**SUBJECT:** Facility Decommissioning Evaluation Building 720-F, Central Alarm Station (G-FDE-F-00062, Revision 2, June 19, 2025) Simple Model and Savannah River Site's Responses to the Regulatory Comments on the Revision 1 Document

**SRS Response to United States Environmental Protection Agency  
Comment on the  
Facility Decommissioning Evaluation (FDE): 720-F, Central Alarm Station,  
G-FDE-F-00062, Revision 1, January 2025,  
Savannah River Site, Aiken, South Carolina**

**SRS Responses to South Carolina Department of Environmental Services  
Comments on the  
Facility Decommissioning Evaluation (FDE): 720-F Central Alarm Station,  
G-FDE-F-00062, Revision 1, January 2025  
Savannah River Site, Aiken, South Carolina**

Figure 3: Labeled Floorplan of 720-F.

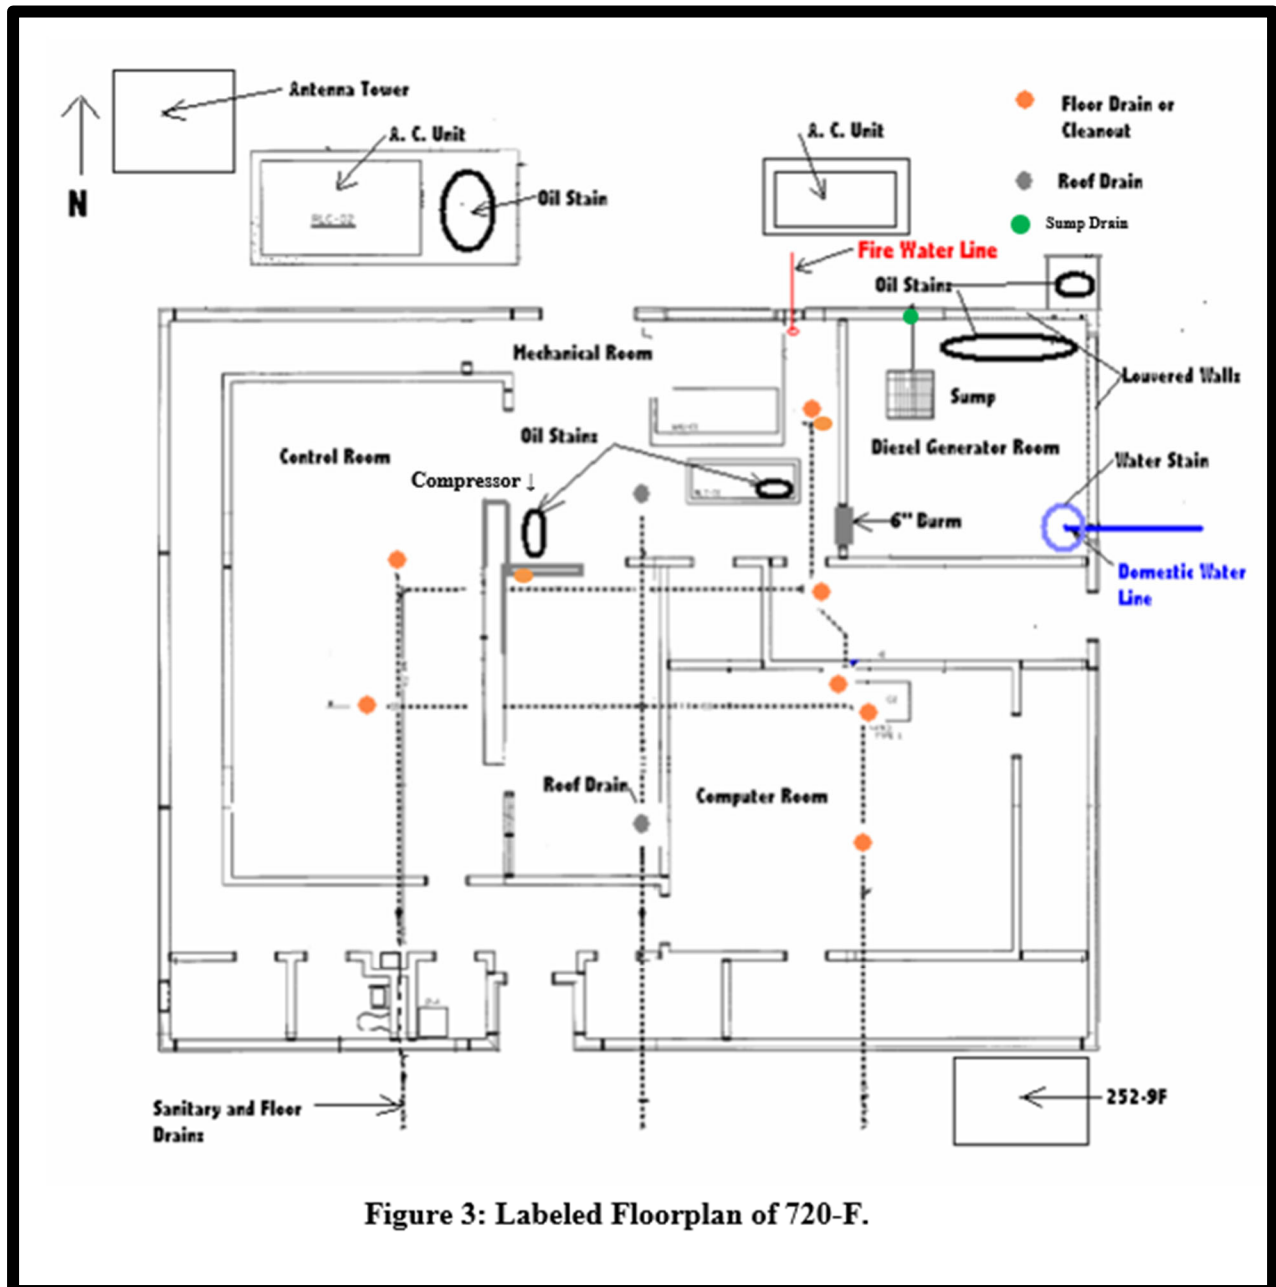
1. Process History, Page 11 of 14: The text should discuss where the liquids that drained into the sump located in the diesel generator room were discharged. The text states that all building floor drains discharged to F-Area sanitary sewer system; however, whether the sump discharged to the sanitary sewer system is unclear. Also, the text should discuss why the sump currently contains water (e.g., the sump discharge line was grouted). *Please revise the text to discuss where the sump liquids were discharged to and if the discharge line has been grouted.*

3. Part 1. Project Scope, Facility Description, page 8. The floorplan in Figure 3 shows a square structure on the northeast corner with oil stains that appears to be on the outside of the building. Please clarify what this structure is and if it is an external structure, what was done to ensure there were no impacts to the surrounding areas outside.

**The room was built to contain the diesel generator so that if it leaked any fluid, it would flow only to the designed low point of the room where the sump is located. There are no sewer drains in the diesel generator room.**

**The sump does not have a drain connected to any other draining system. The sump has its own discharge line at the bottom that comes up a few feet and then out of the northern wall of the building via a 6-inch drain line that would need to be pumped prior to grouting the sump. The sump currently contains rainwater that entered through the louvered windows of the diesel generator room (i.e., the bottom of the sump was not visible). During the decommissioning process, the rainwater in the sump will be pumped out by mechanical means and sampled to determine the appropriate disposition path.**

**Figure 3 will be revised to label the sump drain. The corrected figure is included at the end of these comment responses.**

Edit of Figure 3 to Differentiate the Sump Drain

**“The service inlet used for refueling the diesel generator is located outside of the northeast corner of 720-F (Figure 3). This area included an external mini containment dyke designed to contain any spills that might occur during the refueling process along with a valve designed to capture spills or release rainwater. Spills would have been managed through the ORPS/SIRIM (Occurrence Reporting and Processing System/Site Item Reportability and**
